WMA Water Flood Advice

Re: Proposed Earthworks Timbrell Park
Review of Potential Flood Impacts on Surrounding Property

Job Title
TIMBRELL PARK SPORTSFIELD
TURF DESIGN MINOR WORKS

Drawing Title
BULK EARTHWORKS
LAYOUT PLAN

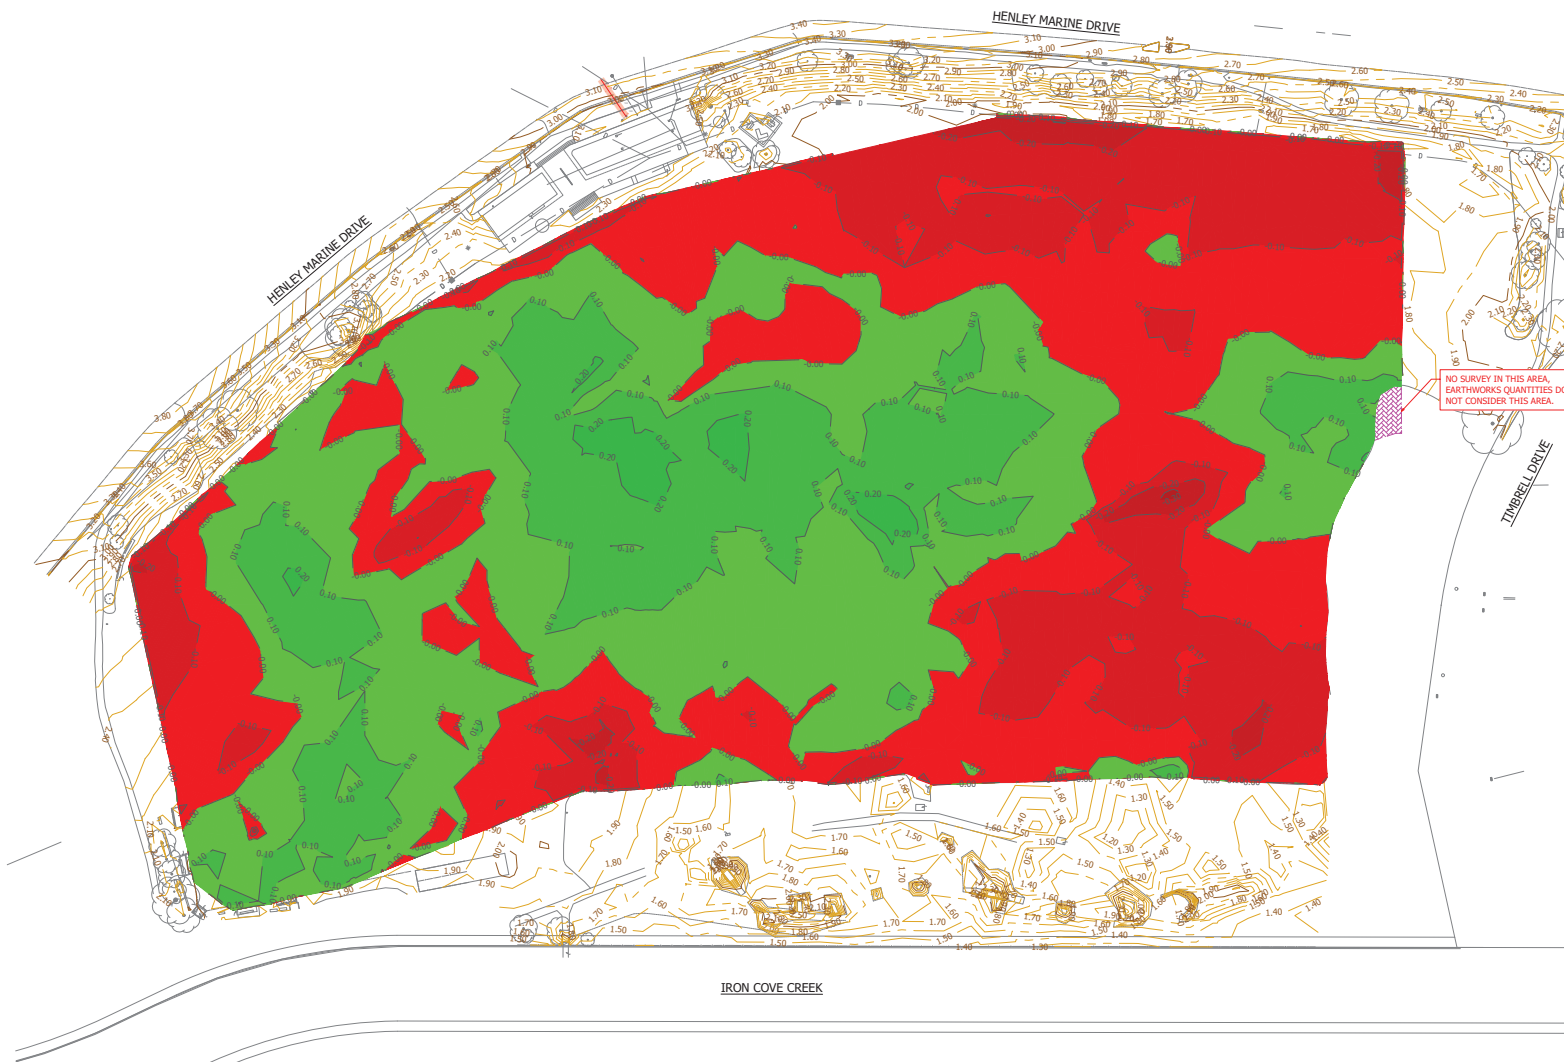
The attached earthworks plan indicates that the volume of fill (2,569 m³) is less than volume of cut (2,602 m³) with 33m³ of material is removed from the site. The works generally change the existing surface by a maximum of +/- 0.2m and thus would not significantly impact on the conveyance of flood flows crossing the site.

Based on the existing temporary floodplain storage capacity of the site being retained (it is to be slightly increased) and the fill not being used to form a barrier to impede the conveyance of flow, the works will not significantly impact on flood levels in the surrounding properties.
